SERVICE ACTION

Service Action
Number: N576v2

Coolant Level Sensor Loose	Subject:
	Publication No.: N576v2
	Model: Defender (LE)
	Model Year: 2020
	Date of Issue: 13 June 2022
	Expiry Date: 30 September 2023

E283547

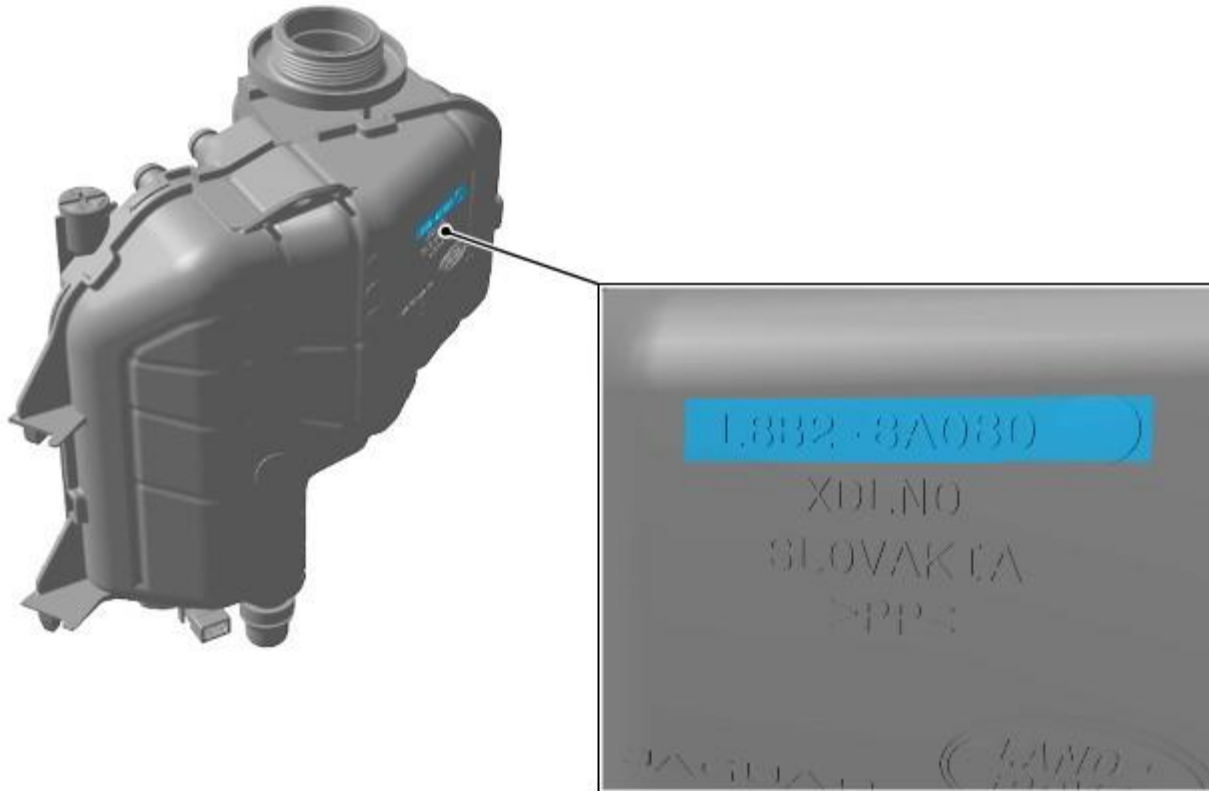
4. Inspect the coolant expansion tank part number.

- If the coolant expansion tank part number is **L8B2-8A080-AF** or **L8B2-8A080-AG**, reverse steps 1 to 3 and release the vehicle.
- If the coolant expansion tank part number is not **L8B2-8A080-AF** or **L8B2-8A080-AG**, continue to the Service Instruction.
